BRIDGE #31  
**WATER AND SEWER FORCE MAIN PROFILE**  
 READSBORO, VERMONT

READSBORO  
 BRO 1441(25)  
 WATER AND SEWER MAIN FORCE PROFILE  
 SHEET 34 OF 80  
 DWG. NO. 416006-C2ED  
 SHEET 1 OF 1

**C2**

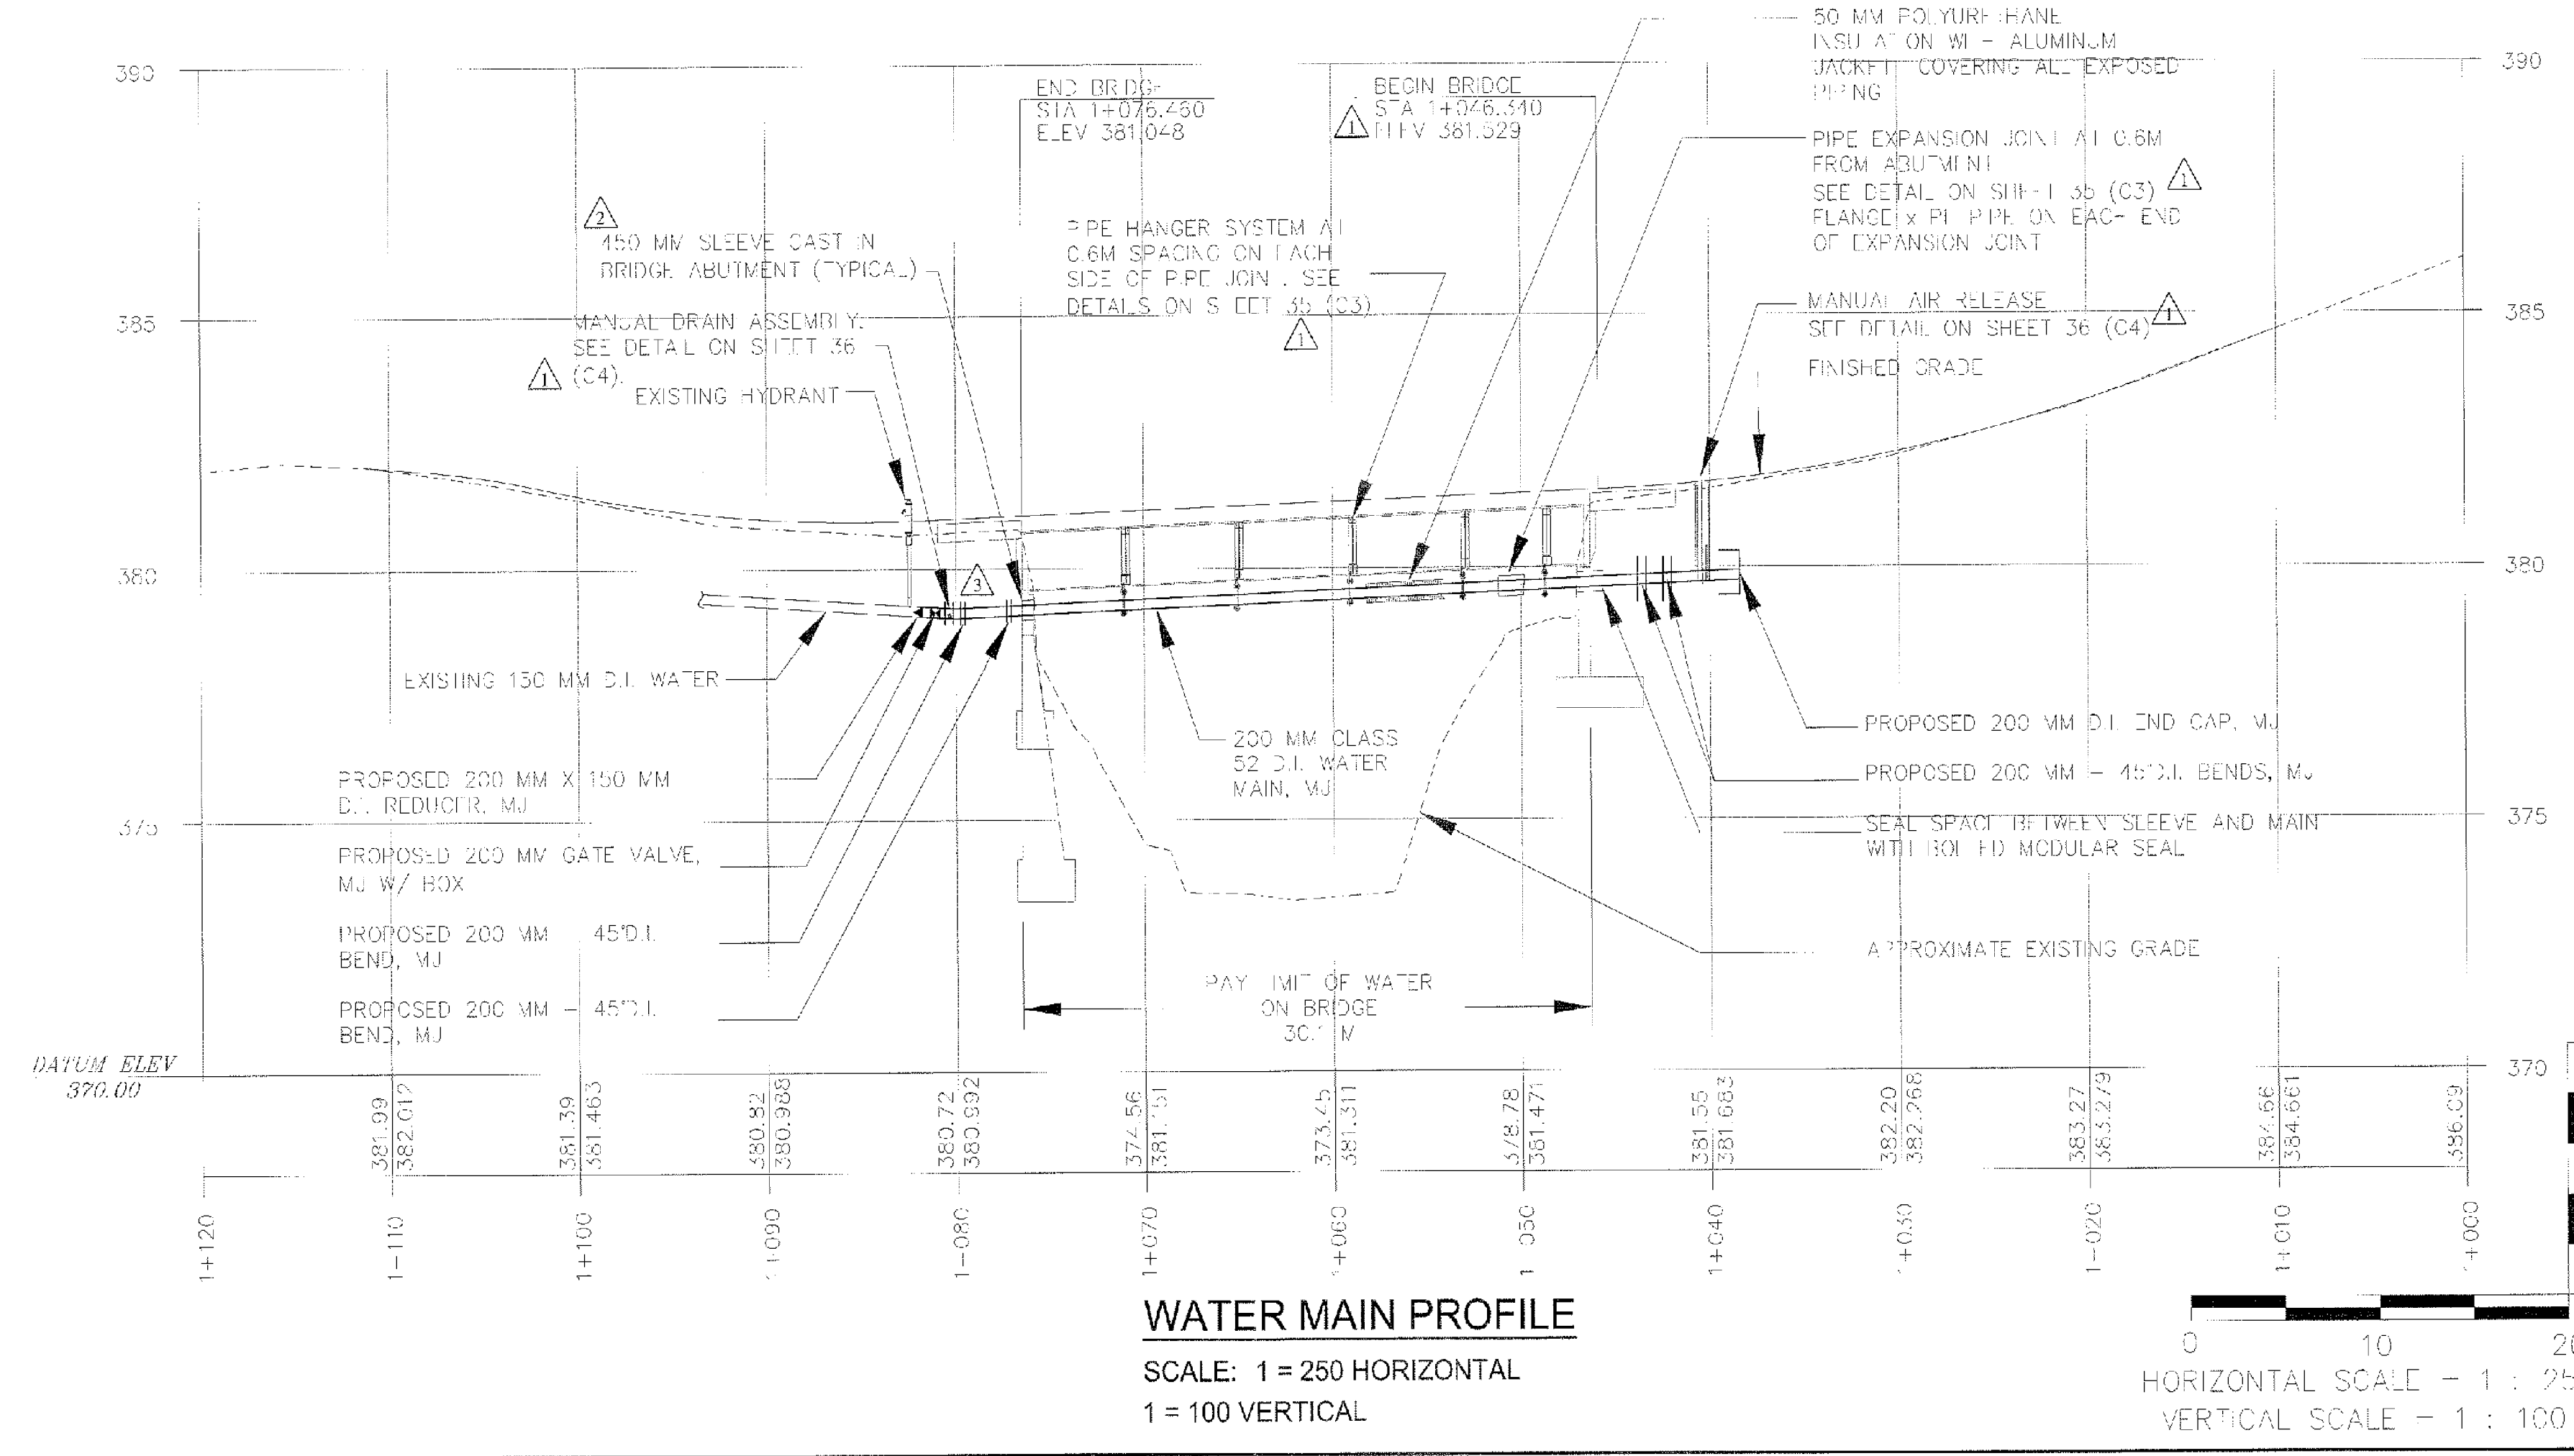
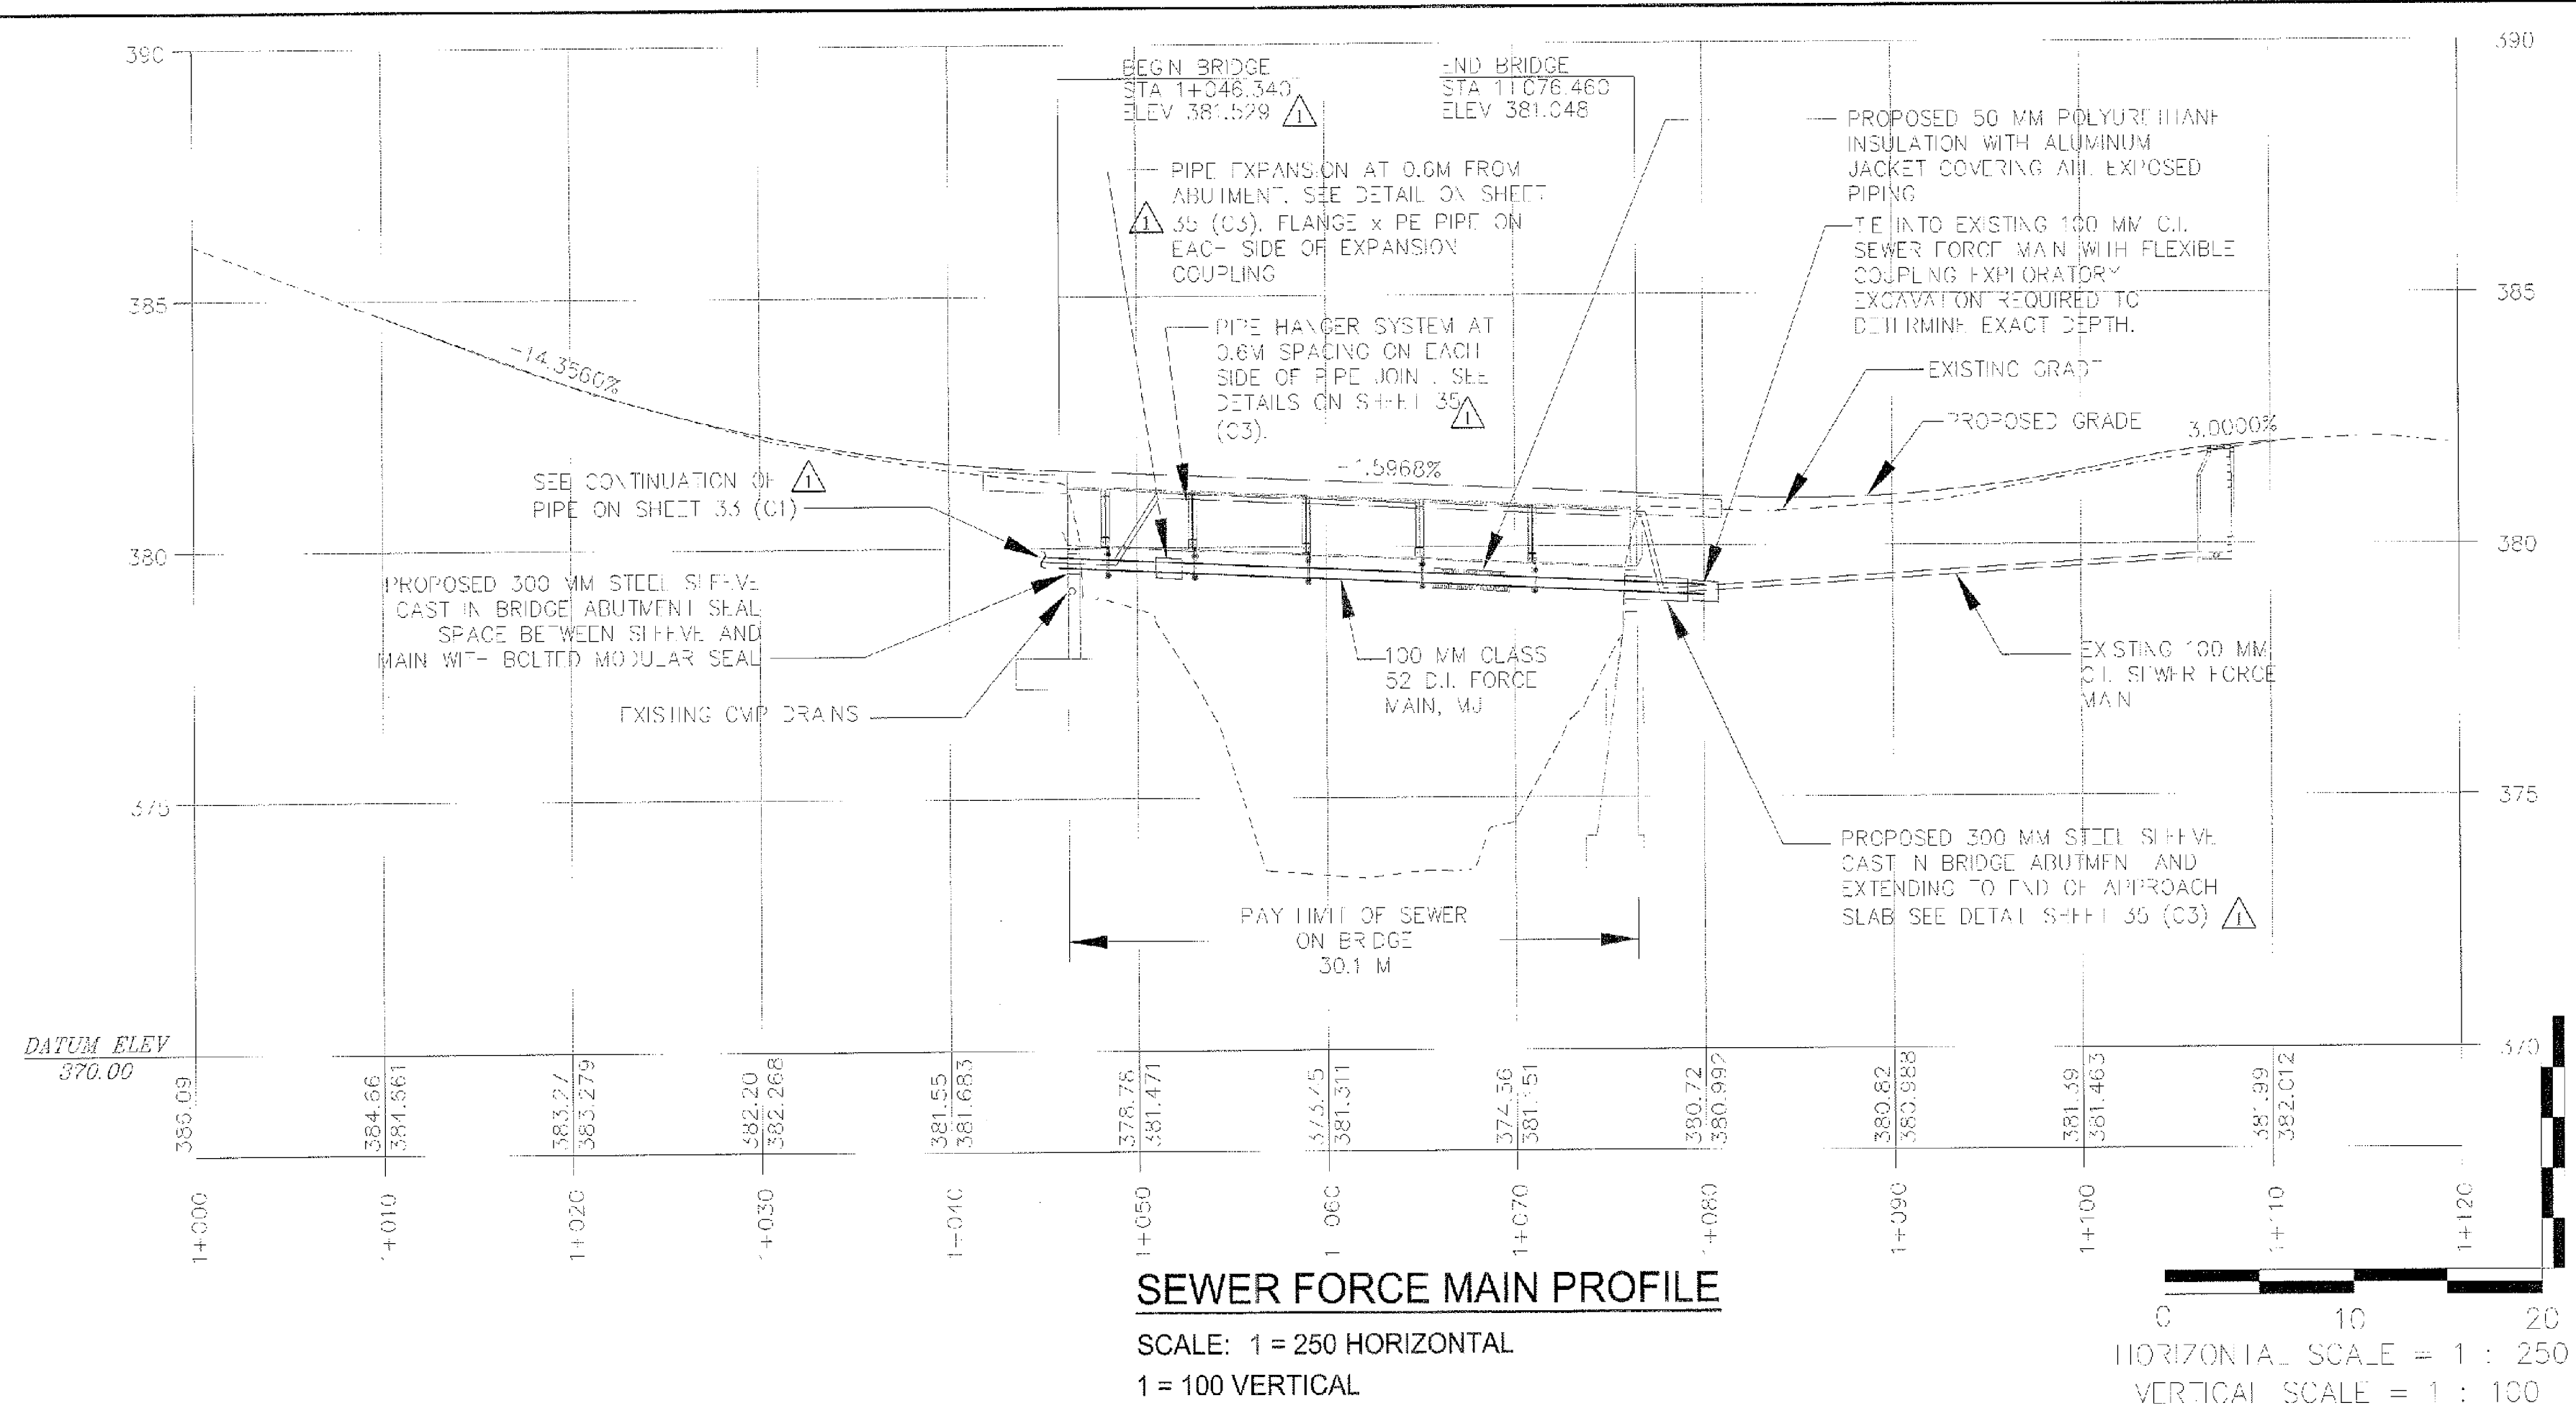
NO WATER MAIN WAS INSTALLED,  
 ONLY THE SLEEVE THROUGH THE  
 ABUTMENTS AND THE HANGER  
 SUPPORT BRACKETS ON THE BRIDGE  
 WERE INSTALLED
